SERVICE KIT 30

HINGED ACCESS DOORS AND BAGGAGE BAY FLOOR INSTALLATION

| By: RCG | | | |
|------------------|--------------------------|-----------------|--|
| Date: 12/13/2017 | DeHavilland DHC-6 Series | 13000 Series | Optional Compliance Service Letter P/N 1002512 |

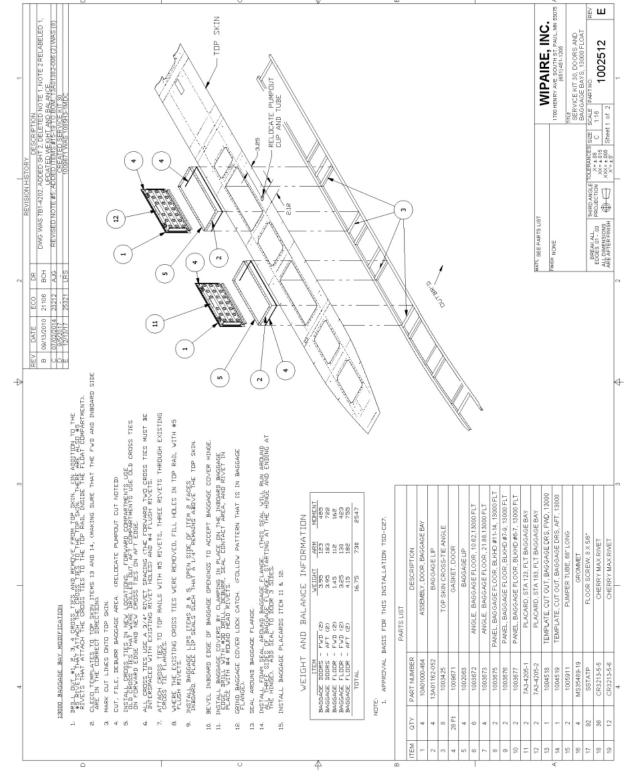
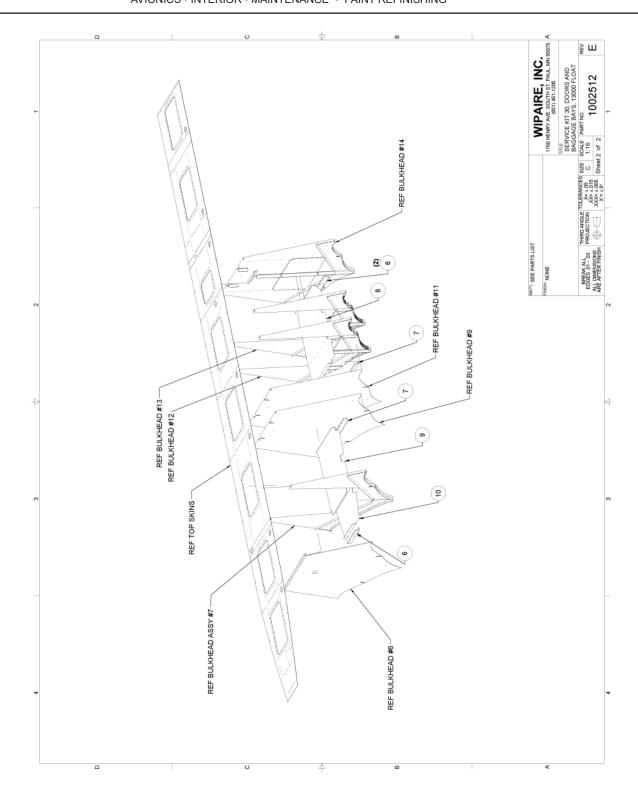
This service kit provides parts to replace the original fixed access covers with hinged baggage doors located on the top deck and install baggage bay floors

1. Perform the modification as shown in the drawings below
